APPEAL SUMMARY

Appeal ID: 22125

Project Address: 1723 NW 24th Ave

LUR or Permit Application No.: 19-126989-REV-01-CO

Floor Plan: Ground Level
3/16"=1'-0"

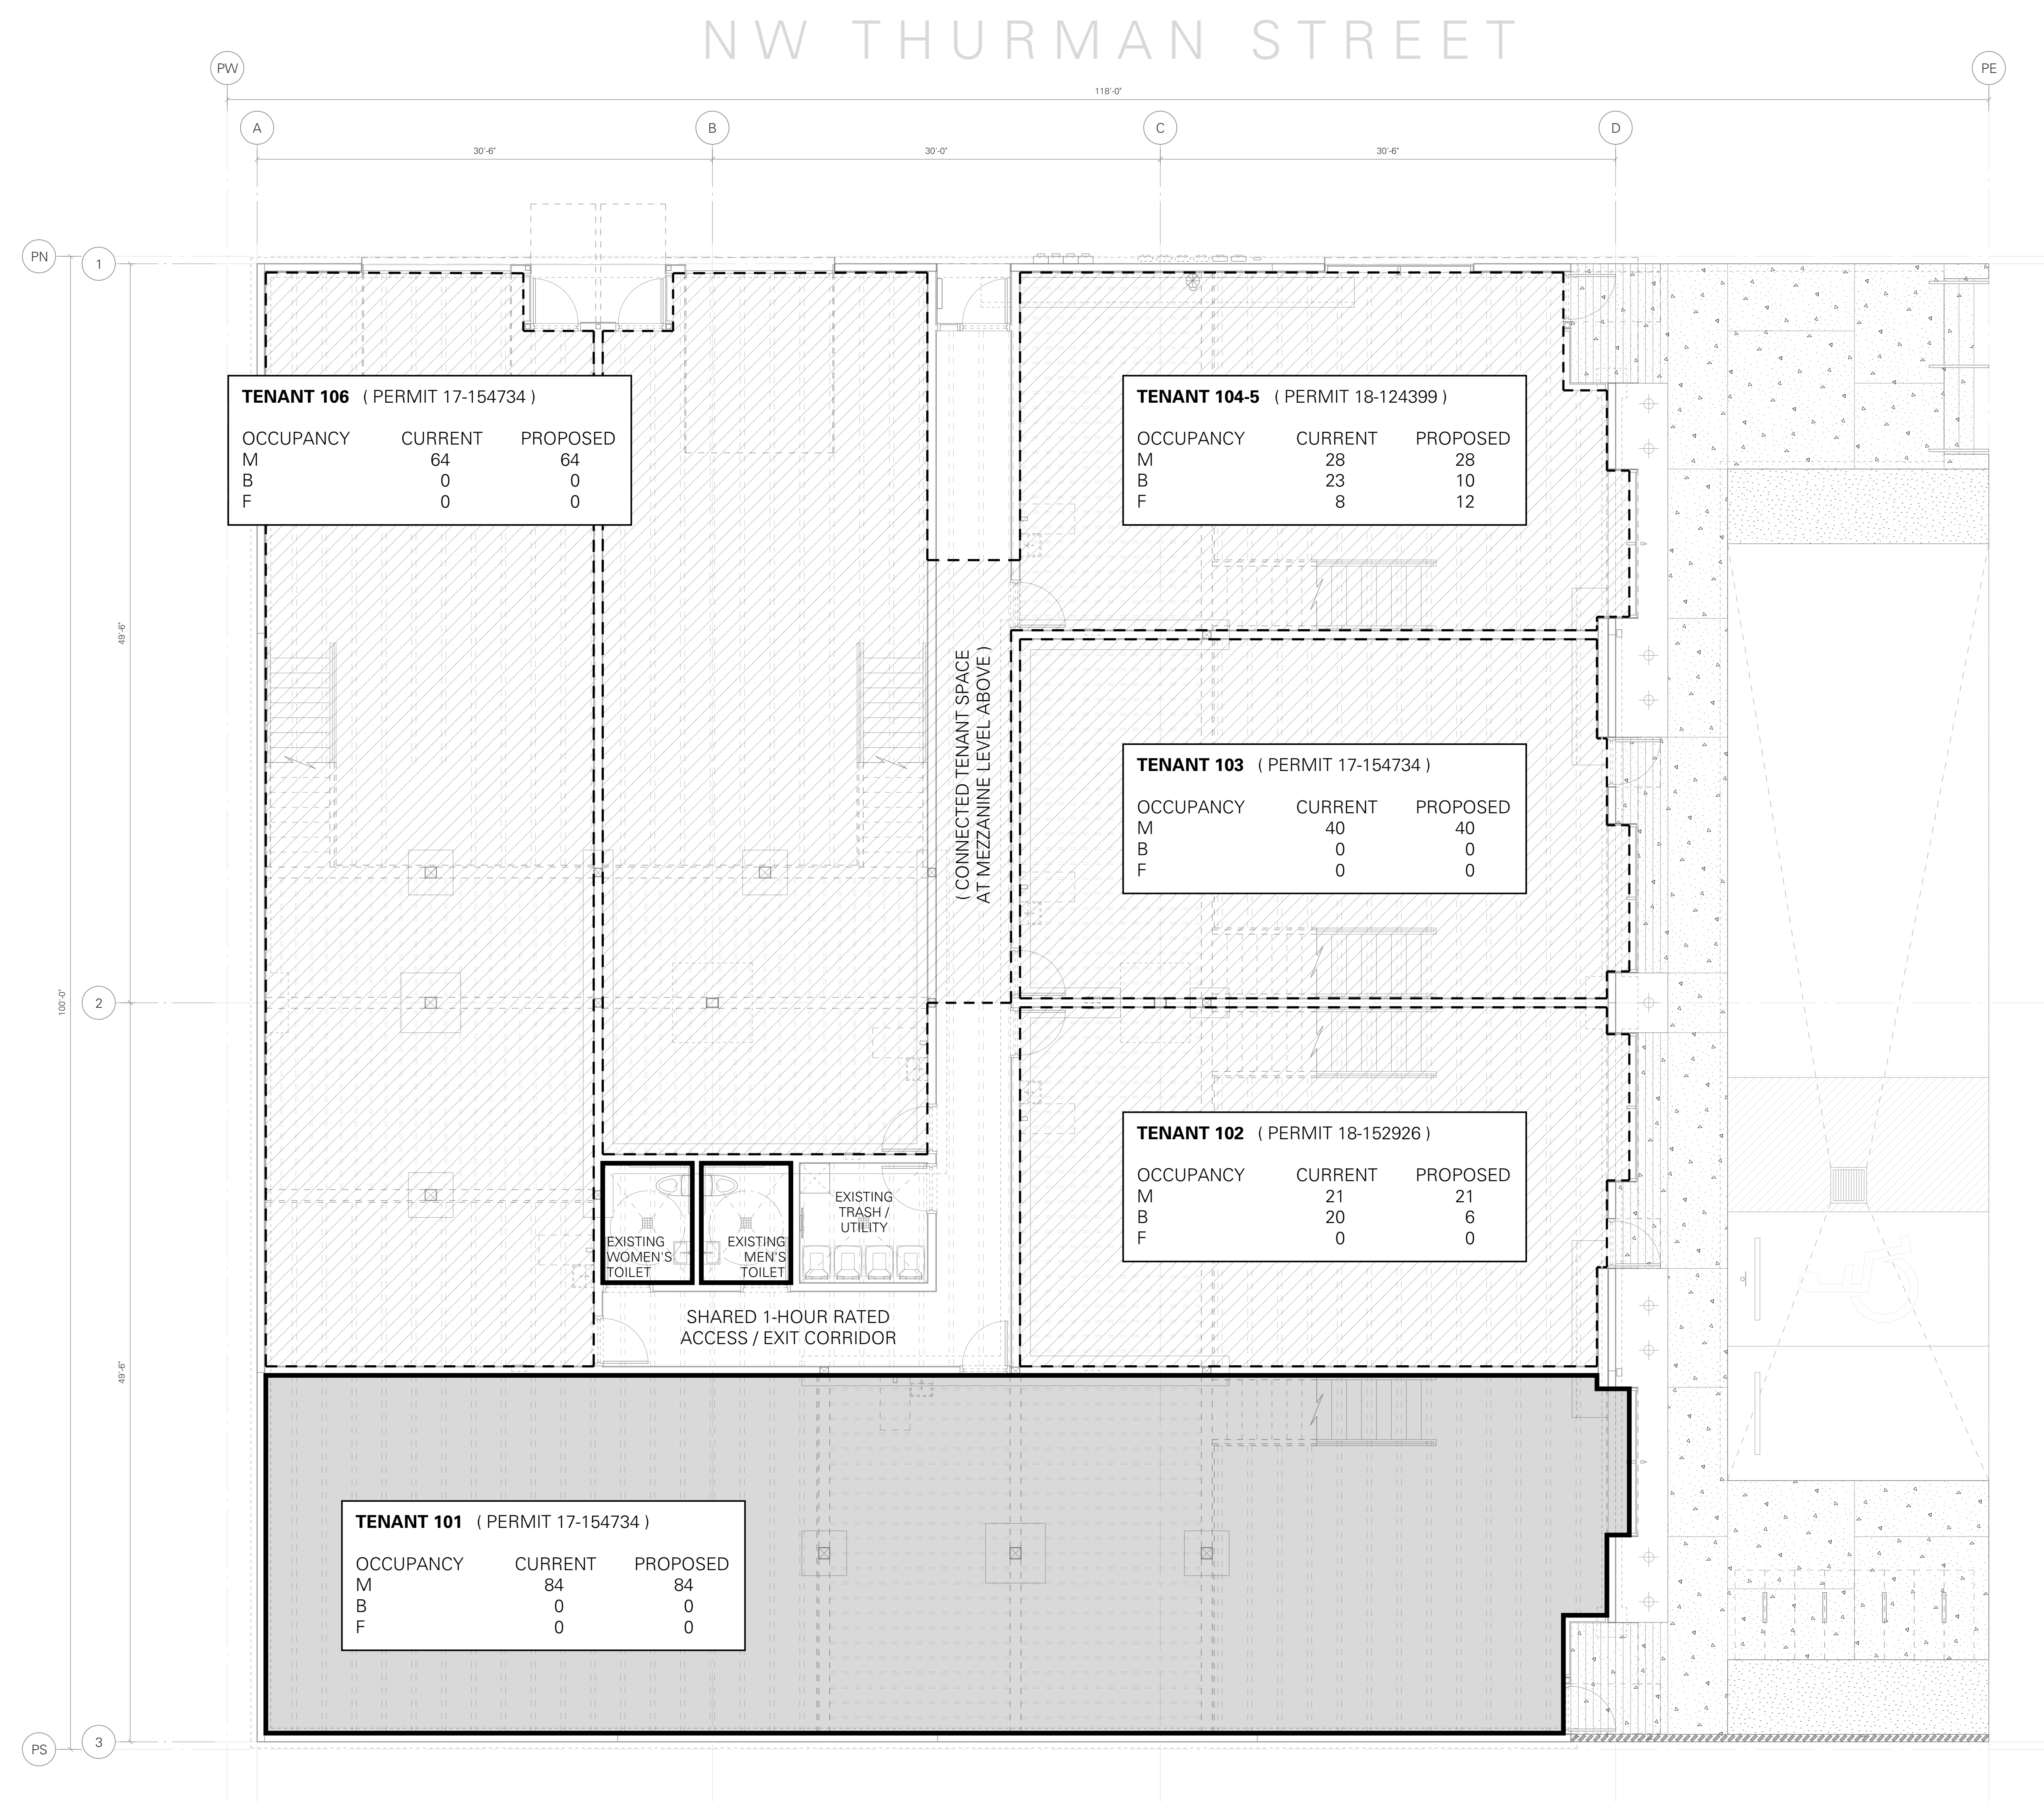
Per checklist item #5, an overall analysis of the existing building with regards to plumbing fixture calculations was requested. We have researched previously approved permits and have determined that two tenant spaces have severely exaggerated occupant loads in relation to their actual uses.

Therefore, we are requesting that more accurate and actual occupant loads as outlined in the following attachments can be used in responding to this checklist.

Overall building ground level plan with current and proposed occupant loads by tenant space

Reduction in minimum required plumbing fixture count: Hold for additional information.
Appellant may contact John Butler (503 823-7339) with questions.

PERMIT #18-152926 (TENANT 102)
PROPOSED OCCUPANT LOADS BASED ON ACTUAL USES
*provided for code appeal informational purposes, November 4 2019

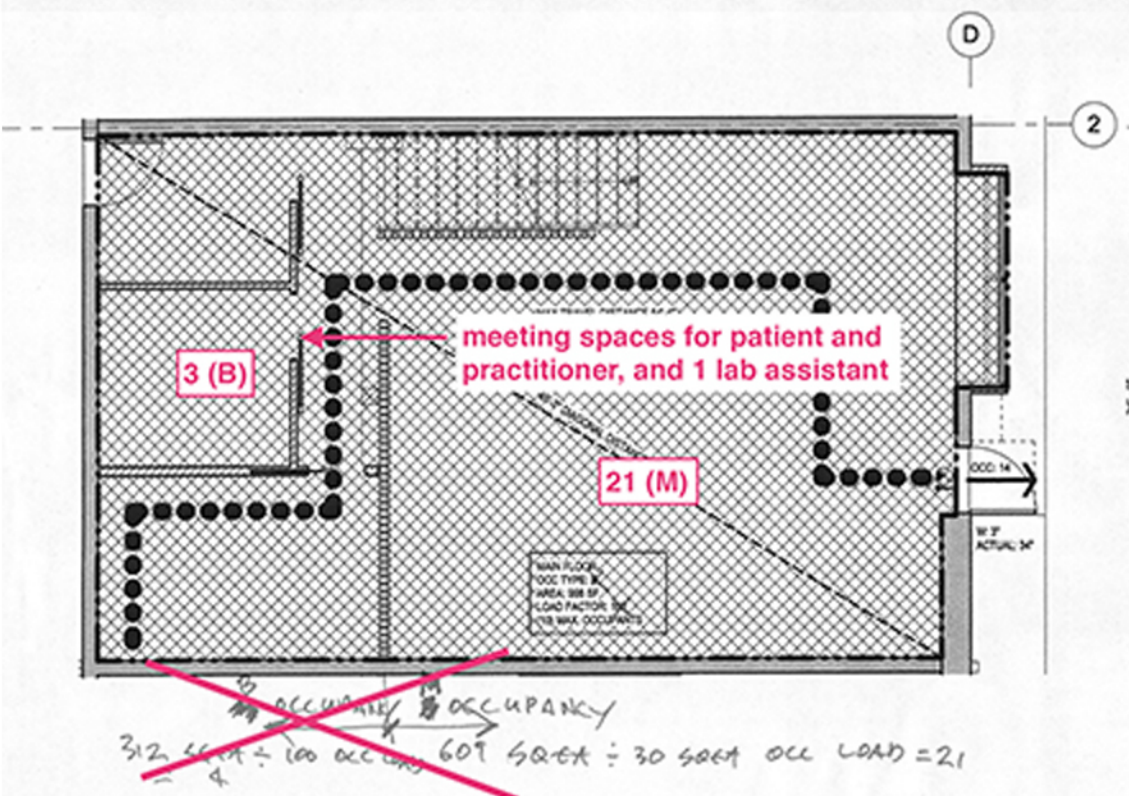
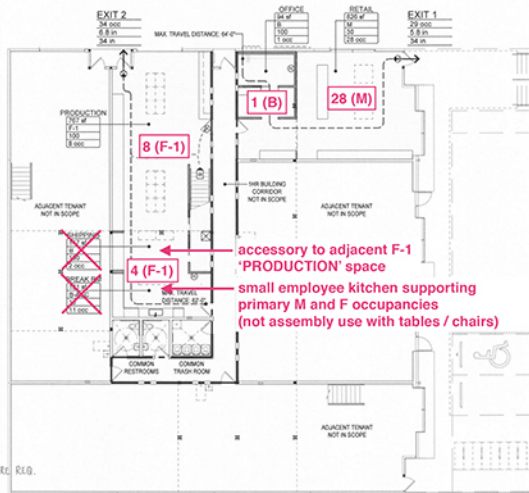
Occupancy plan from permit #18-152926 (Tenant 102) - mark-up showing actual uses with proposed occupant loads
 Occupancy plan from permit #18-124399 (Tenant 104-5) - mark-up showing actual uses with proposed occupant loads
 Overall summary worksheet with proposed occupant loads based on actual uses
 **Additional information for reconsideration:

Permit #18-152926 (Tenant 102). This space is occupied by a small wellness clinic with 2 full-time practitioners and an occasional part-time lab assistant. Due to the size-limited nature of the business, there are never more than 3-4 employees and patients total in the space at a given time, so the application of 16 'B' occupants on the mezzanine level is excessive and unnecessary. It appears this was revised by hand at the permit counter by the applicant and/or reviewer. We are proposing to leave the 'M' portion of the space (at the front where health-related products are sold) as currently permitted.
